TECHNICAL SERVICE BULLETIN

Whistle Noise From Left Exterior Mirror

22-2215

Ford 2021-2022 Bronco

Figure 1 - Left side shown, right side similar

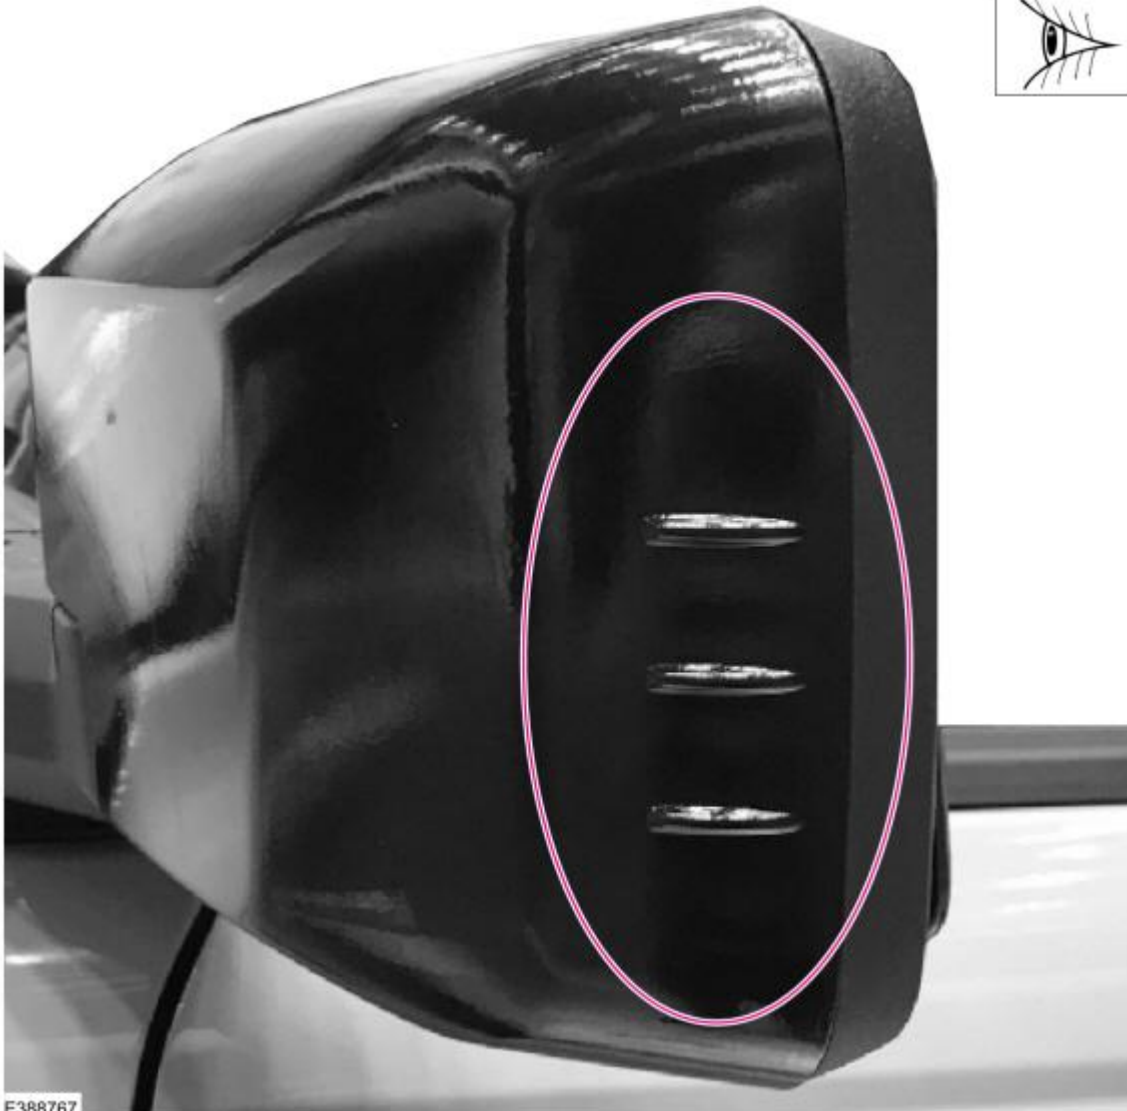
Issue: Some 2021-2022 Bronco vehicles equipped with base exterior mirrors (does not have integrated puddle lamps and/or turn signal lamps) may have a whistle noise that originates from the left exterior mirror. This may be due to the design of the exterior mirror cover. To correct this condition, follow the Service Procedure to replace both the left and right exterior mirror covers.

1. Does the left exterior mirror have 3 horizontal fins on the outboard side of the mirror cover? (Figure 1)

- (1). Yes - this article does not apply. Refer to Workshop Manual (WSM), Section 100-04 and continue with normal diagnostics.
- (2). No - replace both the left and right exterior mirror covers. Refer to WSM, Section 501-09. Both the left and right exterior mirror covers must be replaced to maintain a consistent vehicle appearance.
